Re: Interpretation for SEA 2005-SU-007, Korean Central Presbyterian Church Trustees,
Tax Map 64-2 ((13)) 18; 64-2 ((5)) 1, 2, 3; Landscaping, Fencing, Parking, Bridge, Sign

**Subject: Korean Central Presbyterian Church
Special Exception Amendment: SEA2005-SU-007
Site Plan: 9630-SP-004-2
Letter of Interpretation for Landscaping and Fencing Adjustments
Comment Response**

**Subject: Korean Central Presbyterian Church
Special Exception Amendment: SEA2005-SU-007
Site Plan: 9630-SP-004-2
Addendum to Letter of Interpretation for Landscaping and Fencing Adjustments
date February 11, 2010**

KOREAN CENTRAL PRESBYTERIAN CHURCH
 BULLY DISTRICT
 FAIRFAX COUNTY, VIRGINIA
 LANDSCAPE RELOCATION EXHIBIT - REVISED LAYOUT

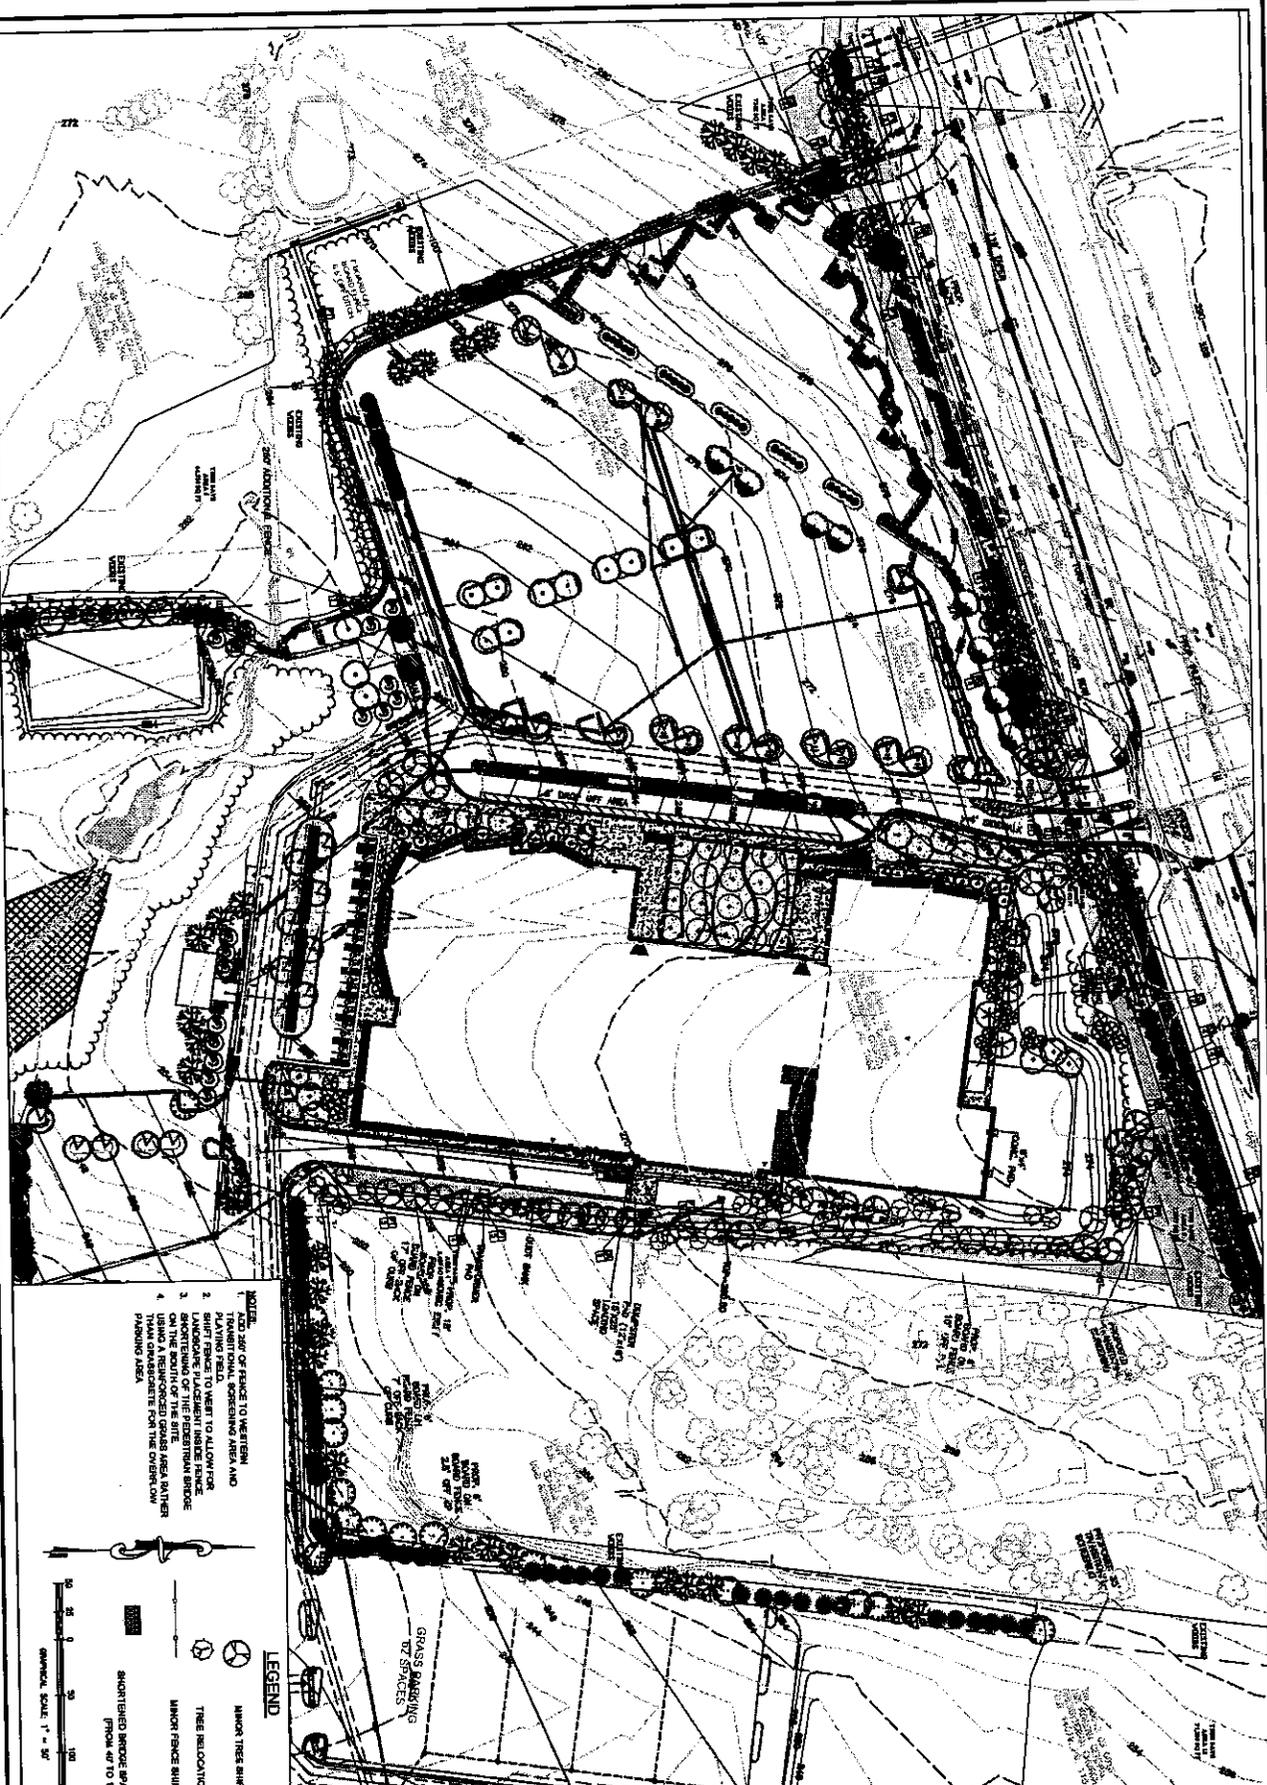
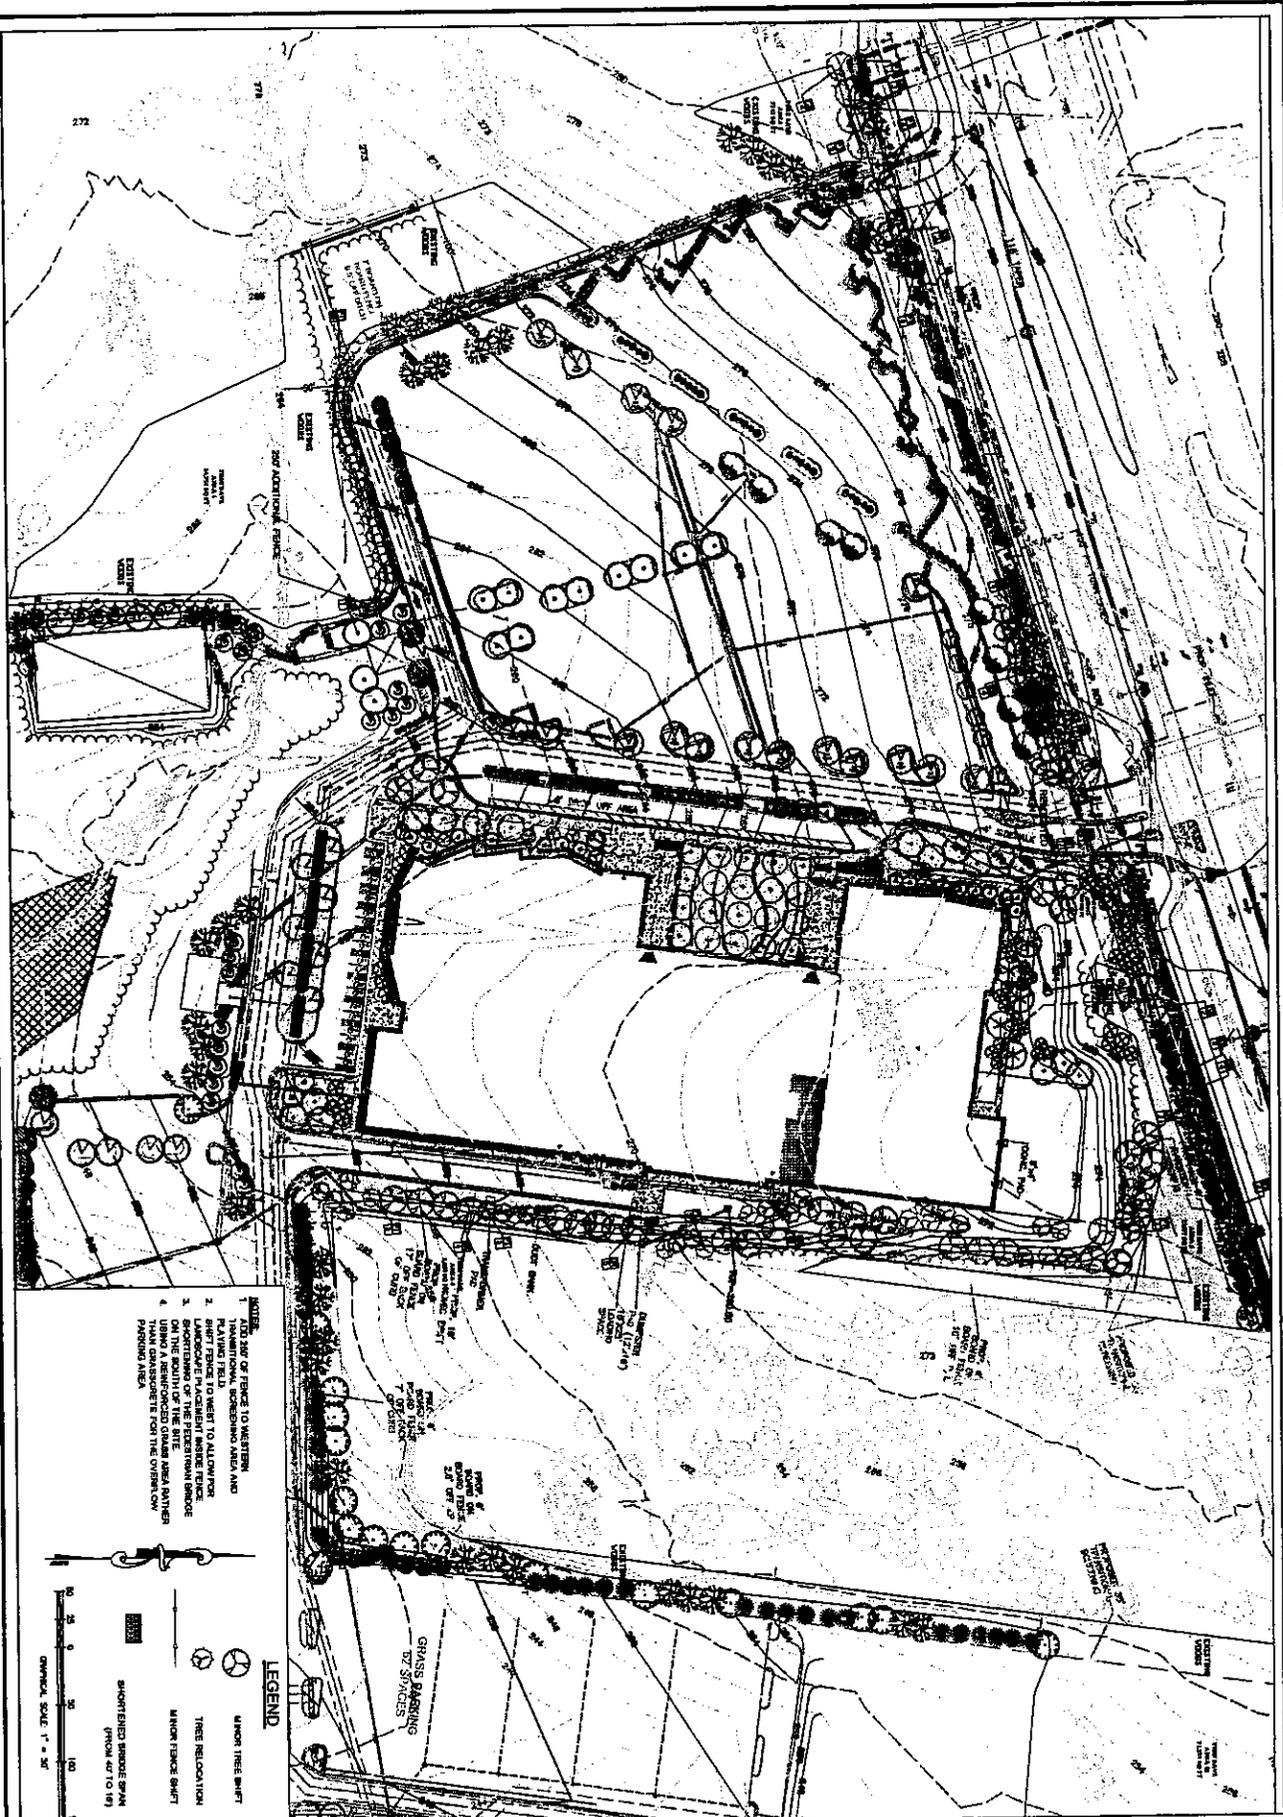
5. **Grass Parking Area Construction Method** – The overflow parking area to the east of the property is indicated on the SE as “Grasscrete” parking area. This parking area is designed to be a pervious grass lot to allow for storm water infiltration and reduce runoff as well as provide other environmental benefits. The “grasscrete” referred to is a specific product utilized in grass parking areas. There are many other construction methods and products available to achieve a grass parking area. We are requesting to change the note on the SE to “grass” parking area to allow for flexibility in the selection of the actual construction method.

6. **Relocate Site Sign** – The site monument sign was shown on the SE and Site Plan located just to the west of the main entrance and oriented perpendicular to Route 29. At this time we are requesting to relocate the sign so that it is parallel with and slightly closer to Route 29 to improve visibility of the address for Fire and Rescue operations. No other adjustment to the sign is being proposed other than the locational change.

It is my determination that the designation of the overflow parking area as "grass" would not be in substantial conformance with the SEA Plat and development conditions. It is my determination that the use of a substitute material to grasscrete would be in substantial conformance with the SEA Plat and development conditions provided that DPWES determines the substitute material provides equivalent performance to grasscrete.

It is my determination that the proposed reorientation of the sign would be in substantial conformance with the SEA Plat and development conditions provided all requirements of Article 12 of the Zoning Ordinance and SEA Development Condition 10 are met and that the sign is no closer to the proposed right-of-way property line than shown on the SEA Plat.

BRIDGE EXHIBIT

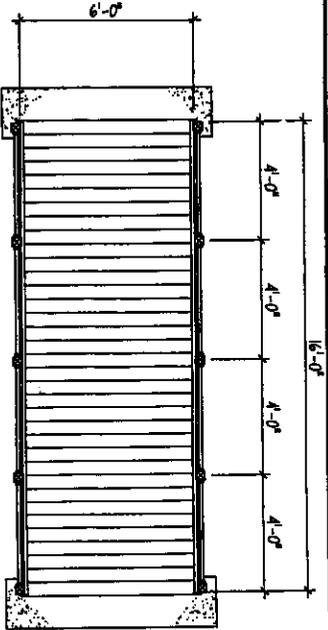
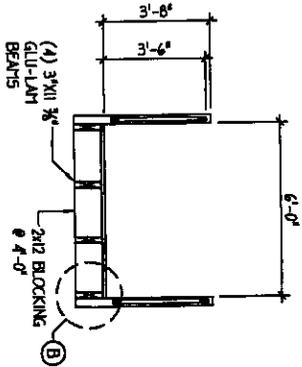
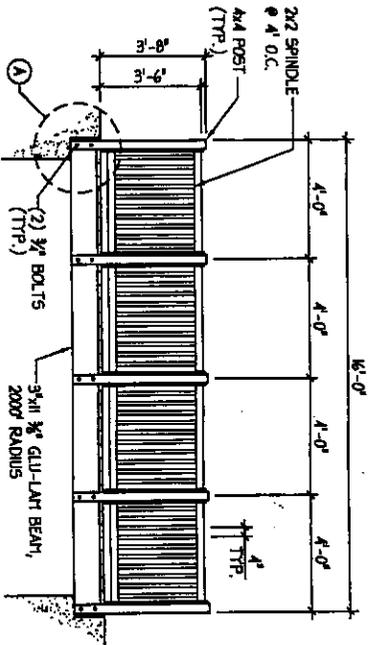
4. Footbridge Span Length - Your fourth question is whether the reduction in length of the bridge shown on the SEA Plat south of the southwestern parking area from 40 feet to 16 feet would be in substantial conformance with the SEA Plat and development conditions. You have provided the plan entitled "Korean Central Presbyterian Church - Bridge Exhibit" Sheet 1 of 1, dated April 26, 2010, and prepared by Bury + Partners and a detail drawing of the bridge on the plan entitled "Korean Central Presbyterian Church - Bridge" prepared by The Kachele Group. These two plans detail a 16 foot bridge span to cross the sensitive wetland area in this portion of the property. DPWES has indicated that the design and length of the bridge must not obstruct, interfere with or change the drainage in the wetland area and that the beams, piers and abutments

4. **Reduce Footbridge Span Length** - Upon further engineering analysis and measurement of field conditions, the clear span required to cross the small drainage way and wetland area between the parking lot and the proposed playing field was found to be sixteen (16) feet. The SE plan had an assumed length of forty (40) feet. This length was estimated prior to more detailed site investigations and research on bridge materials. We propose to install a bridge and path in accordance with the SE but utilizing the shorter span needed to cross the sensitive area. A plan view of this area is attached to this letter for review. A copy of the plan illustrating the proposed footbridge is also included for reference.

must not affect the flow of water. It is my determination that a reduction in the length of the bridge would be in substantial conformance with the SEA Plat and development conditions provided DPWES determines that the above conditions are met at the time of site plan approval. The amount of reduction, if any, shall be determined by DPWES.
